TITLE:  
ITEM NO:  
DESC.: PLAN, ELEVATIONS, DETAIL  
DESC.: CAFE PANTRY 3392

By: PD Scale: As Noted Job No. Dwg. No.  
Status: IN SUBMITTAL REVIEW Date: 2019-07-08 **02-01**

TITLE:	SECTIONS	Job No.	Dwg. No.
ITEM NO.:	CAFE PANTRY 3392	Scale: As Noted	02-04
DESC.:		Status: IN SUBMITTAL REVIEW	Date: 2019-07-08

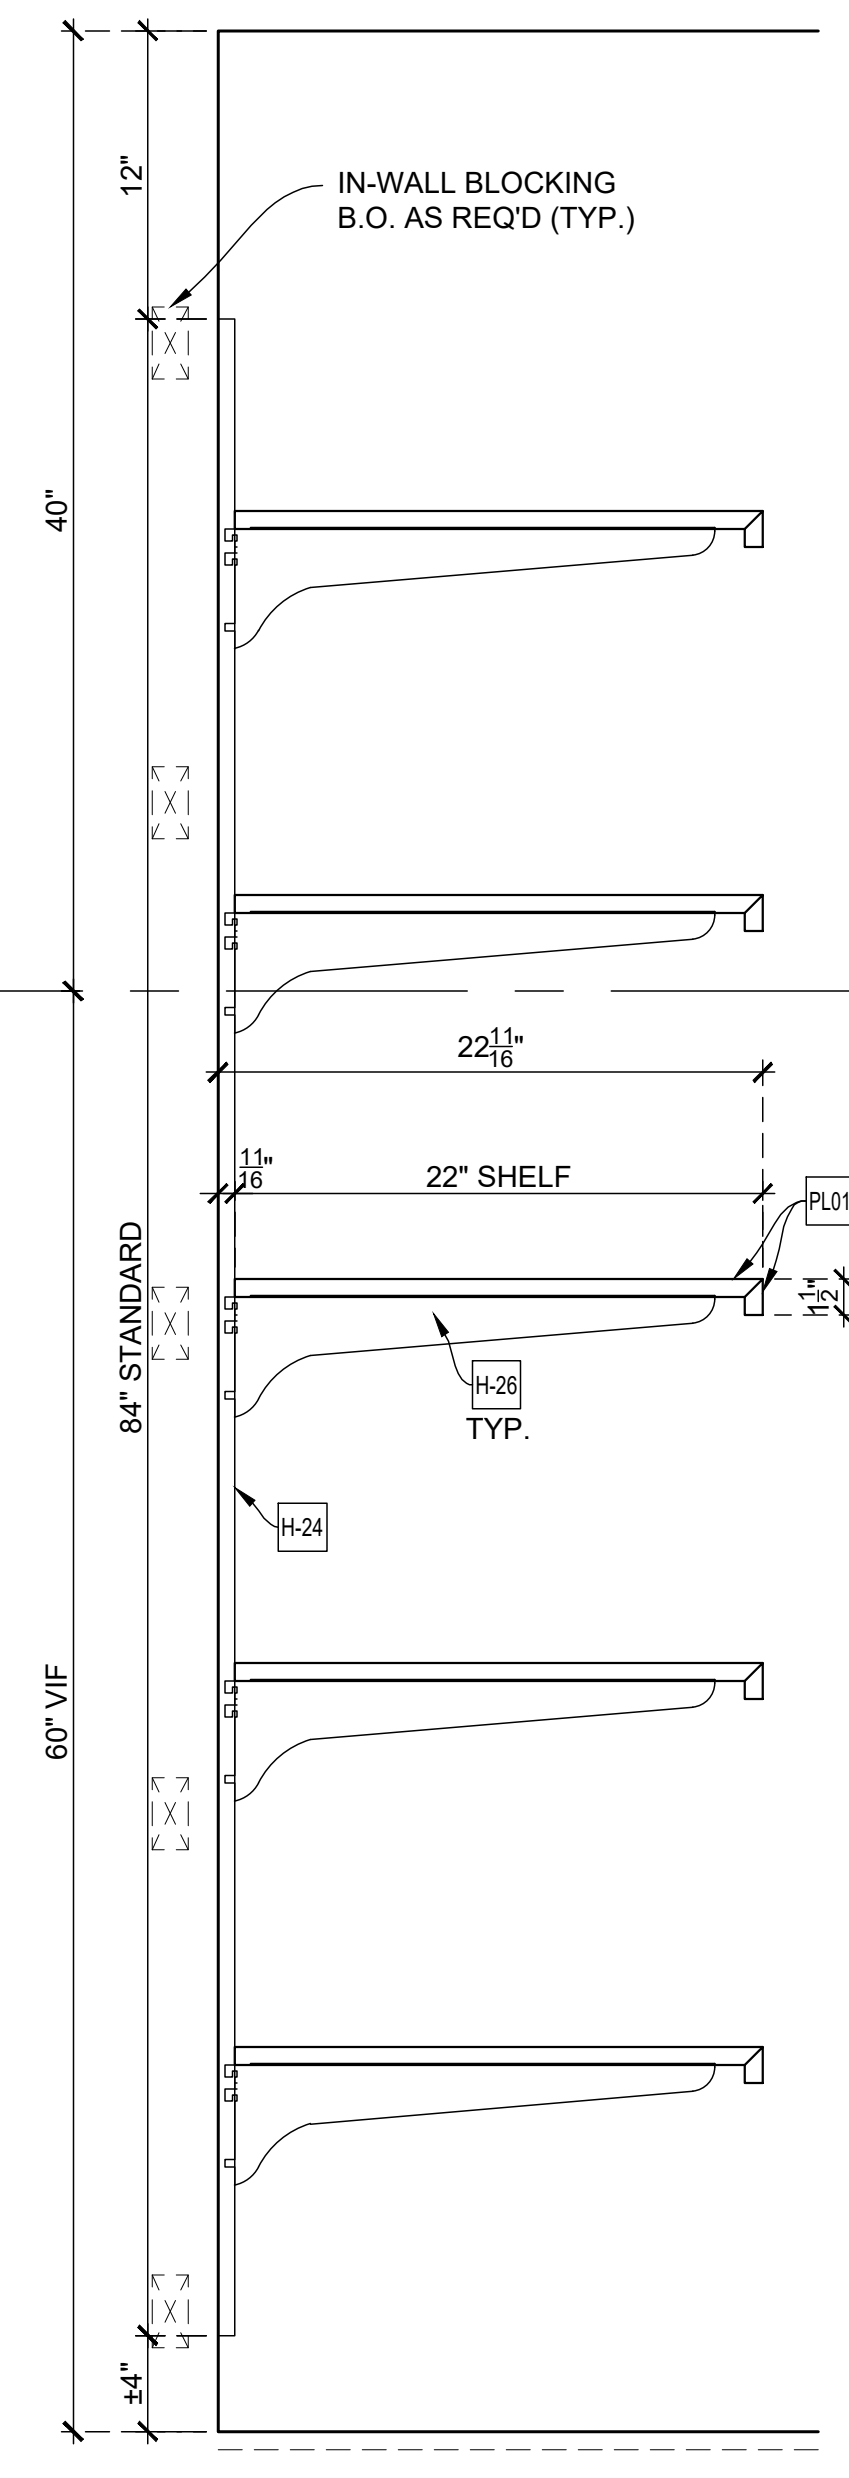
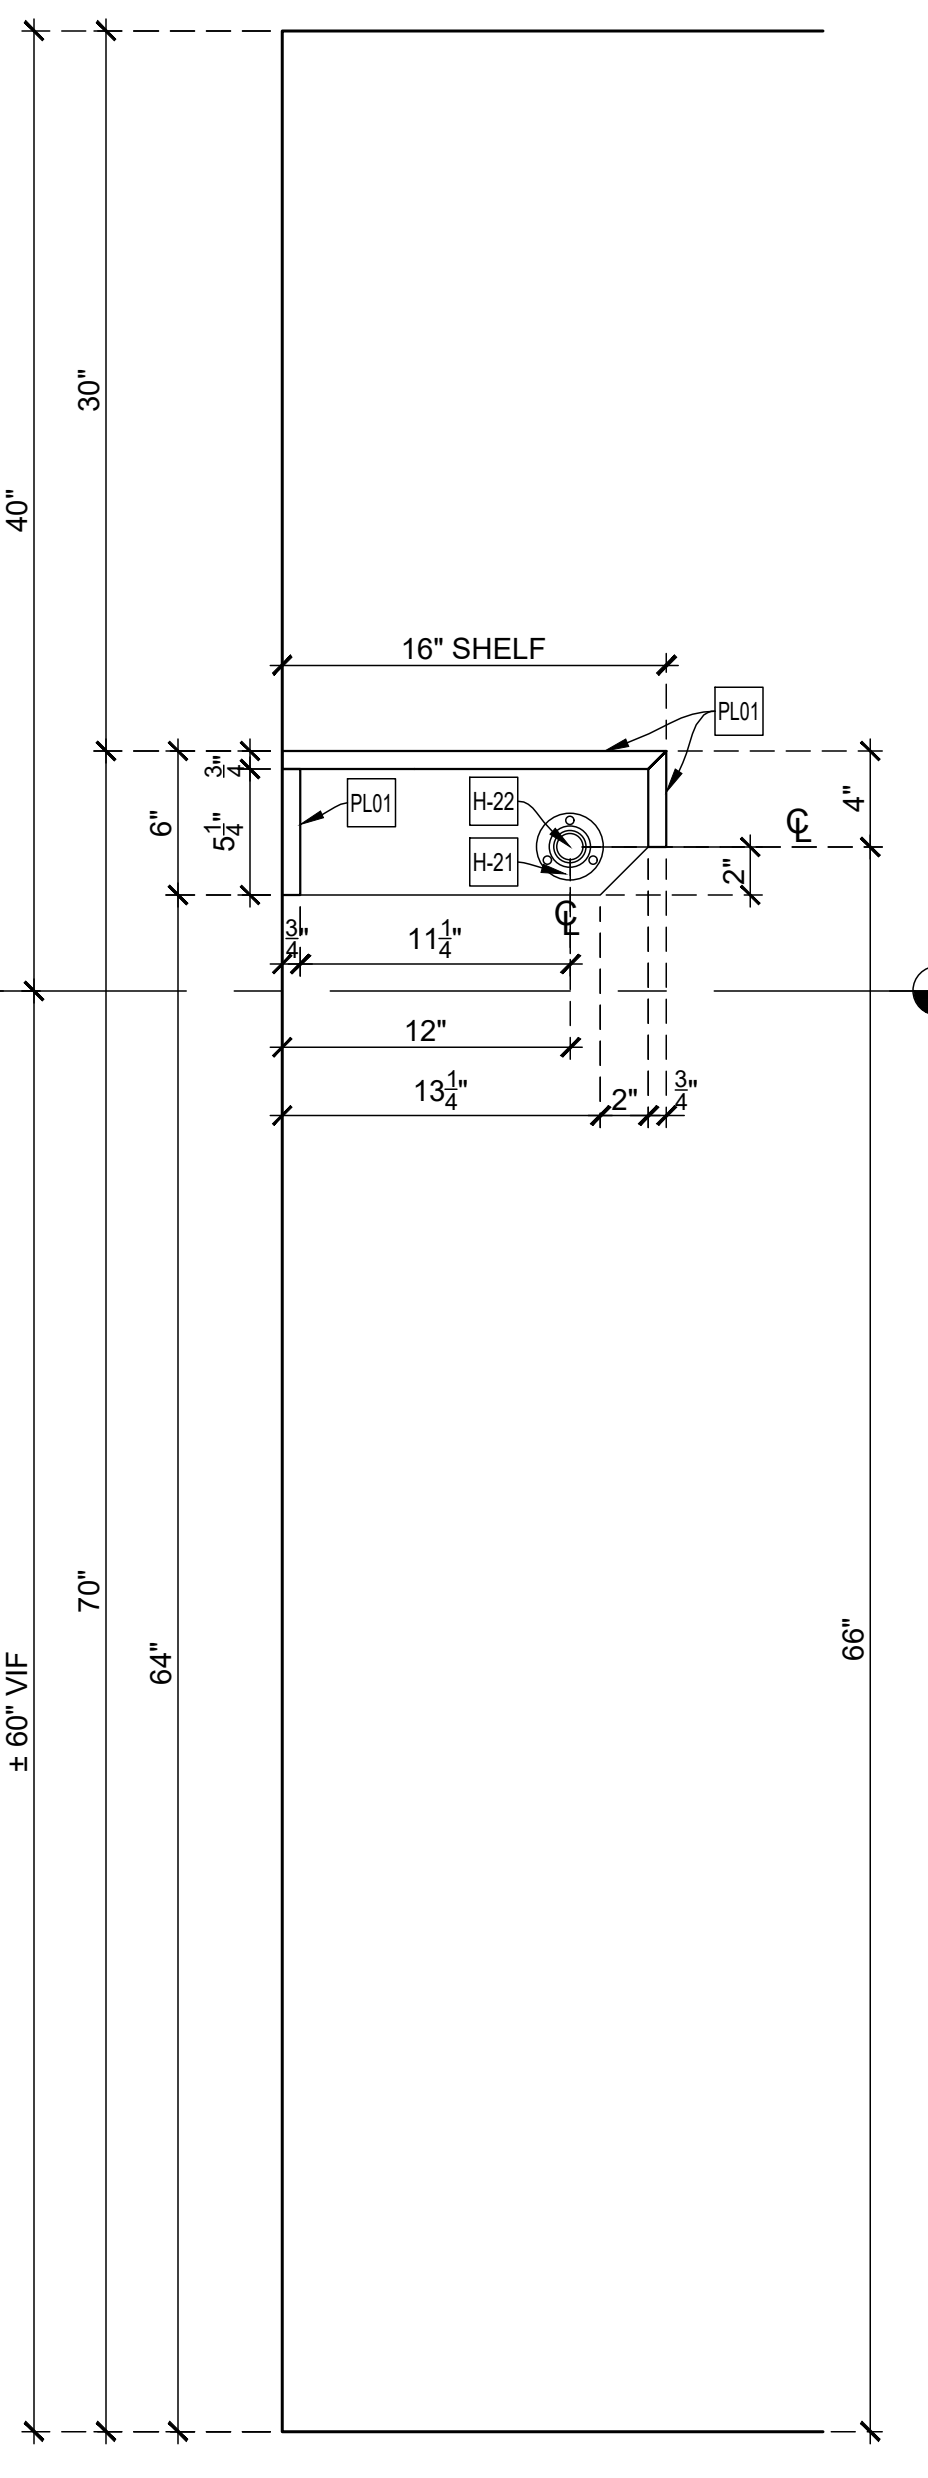
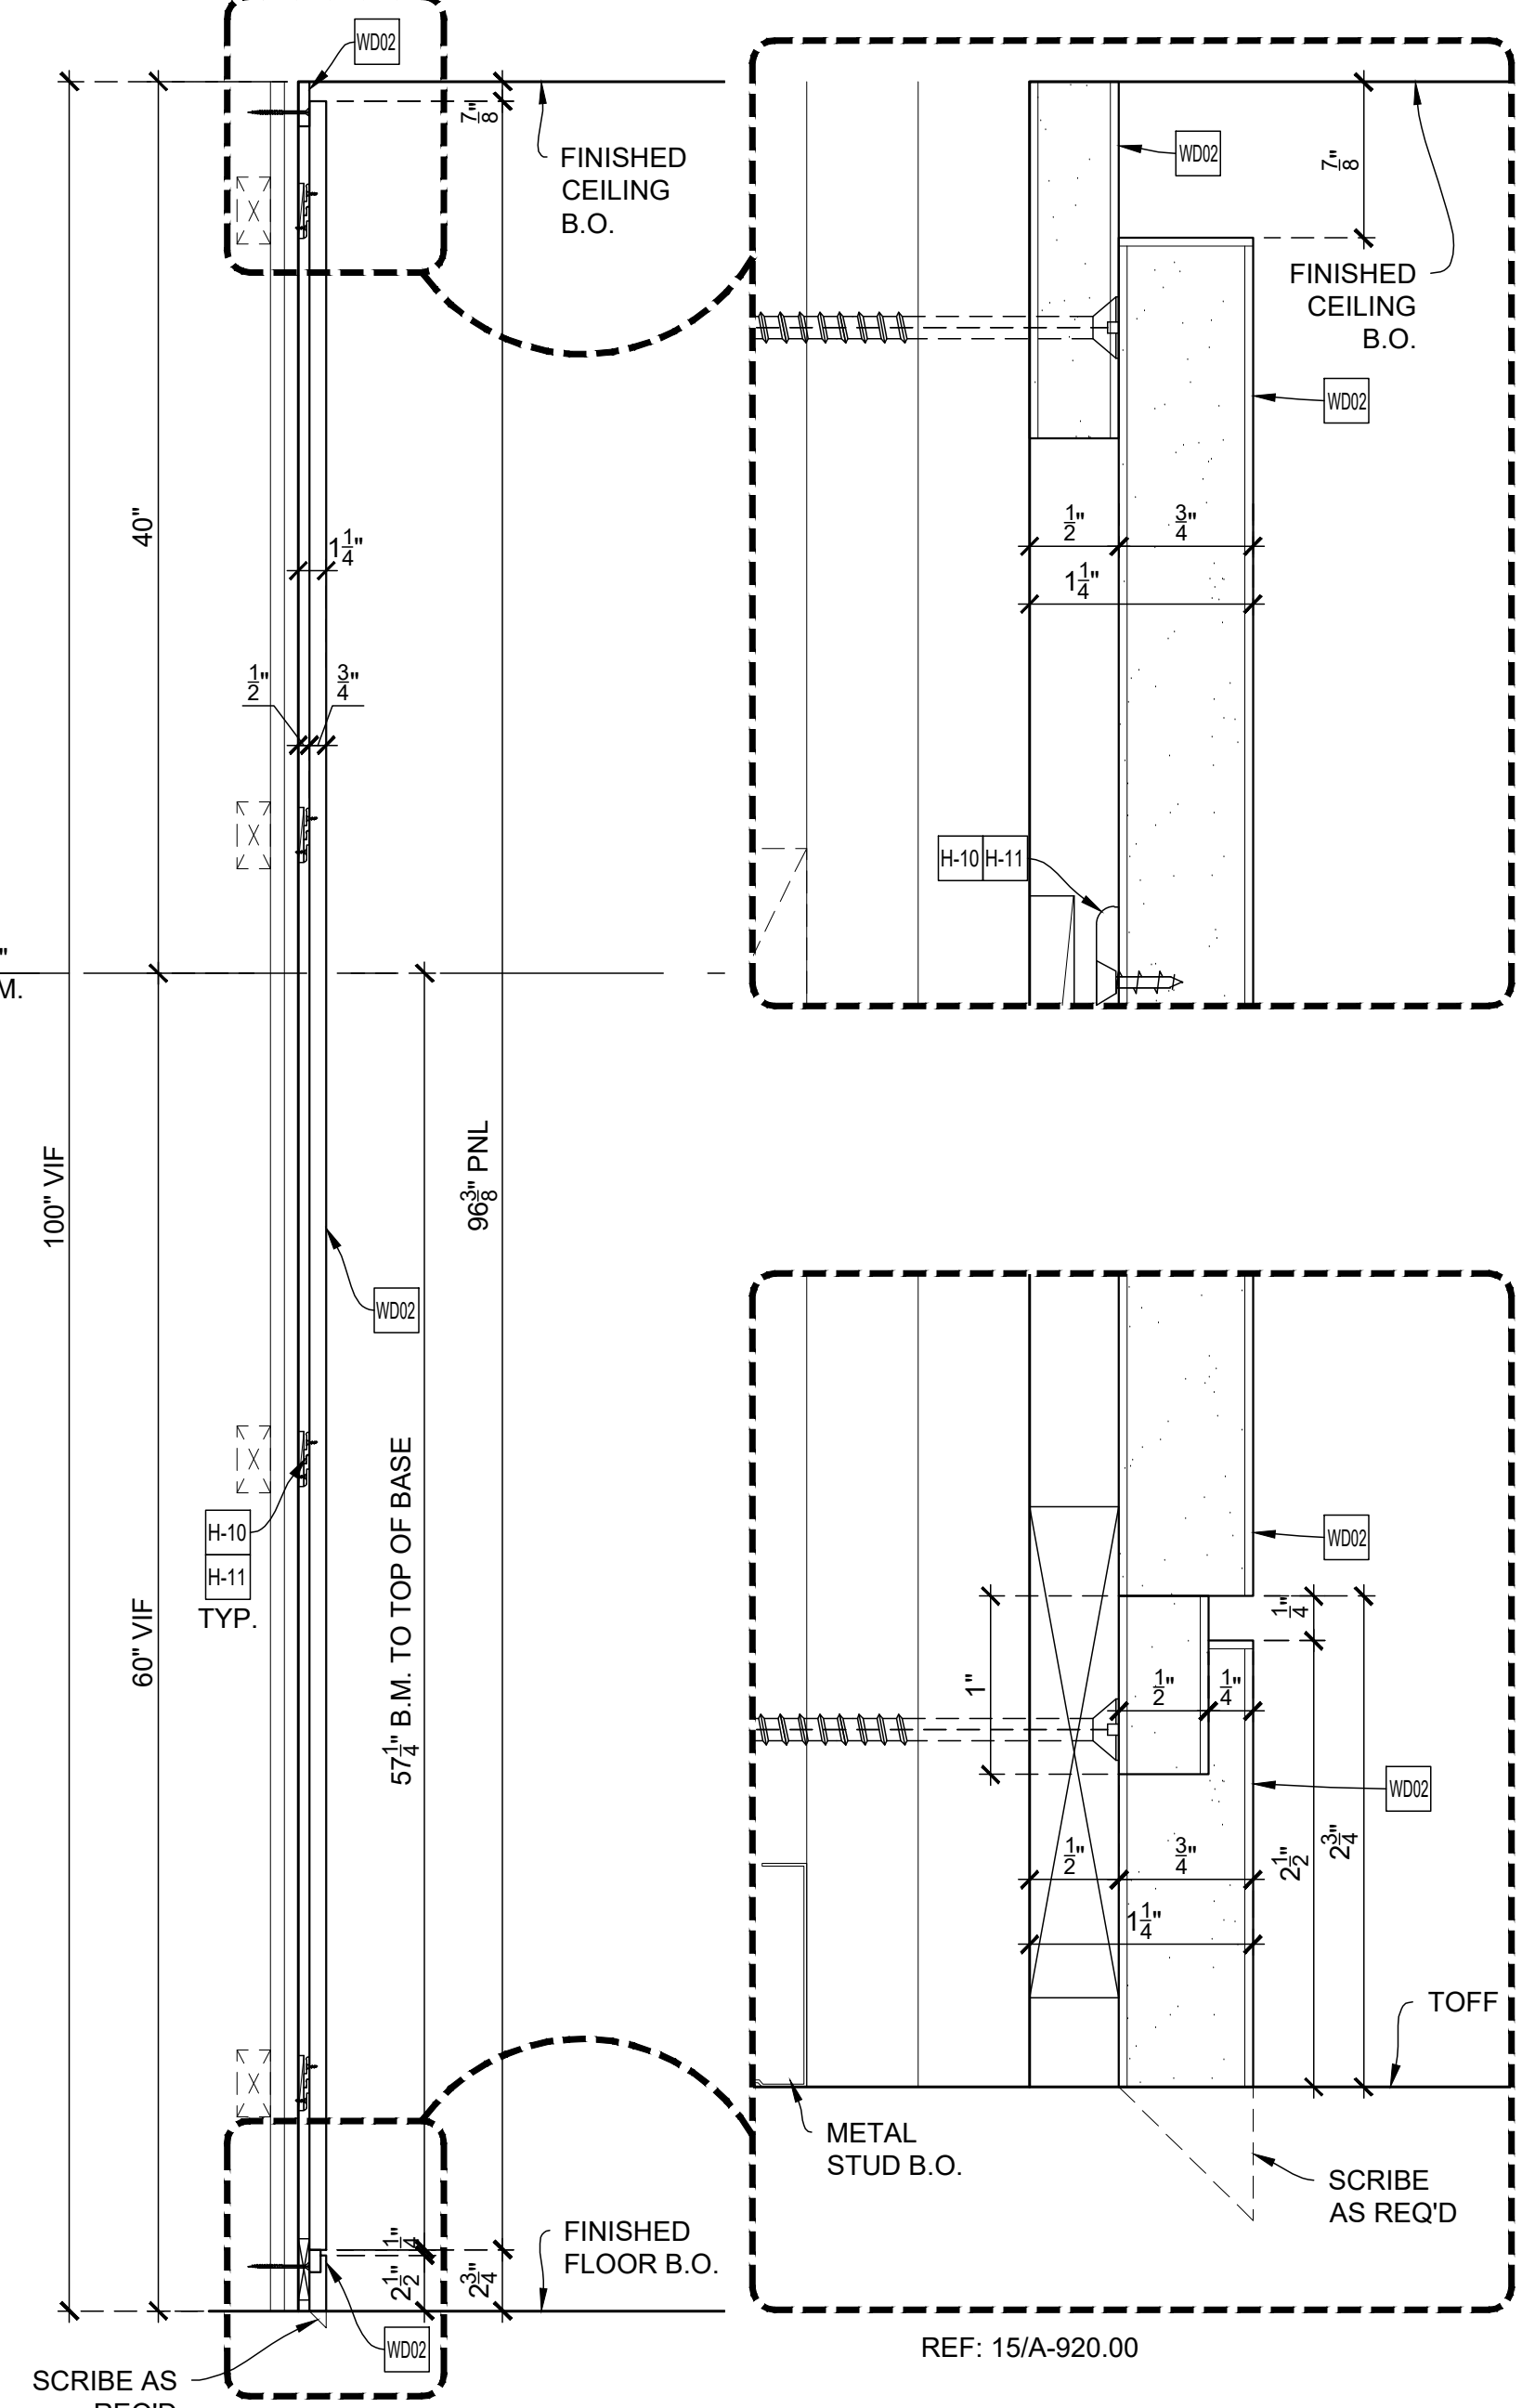
ARCHITECT NOTE:  
PLEASE VERIFY USE OF CABINET WITH DOOR  
INSTEAD OF FIXED PANEL ABOVE REFRIGERATOR

ARCHITECT NOTE:  
PLEASE VERIFY ALL WOOD  
GRAIN DIRECTIONS.

PLEASE VERIFY ALL WOOD GRAIN DIRECTIONS.  
 PLEASE VERIFY SECTION DUE TO LACK OF DETAILS ON ARCHITECTURAL DRAWINGS.

ARCHITECT NOTE:  
PLEASE VERIFY SECTION DUE  
TO LACK OF DETAILS ON  
ARCHITECTURAL DRAWINGS.
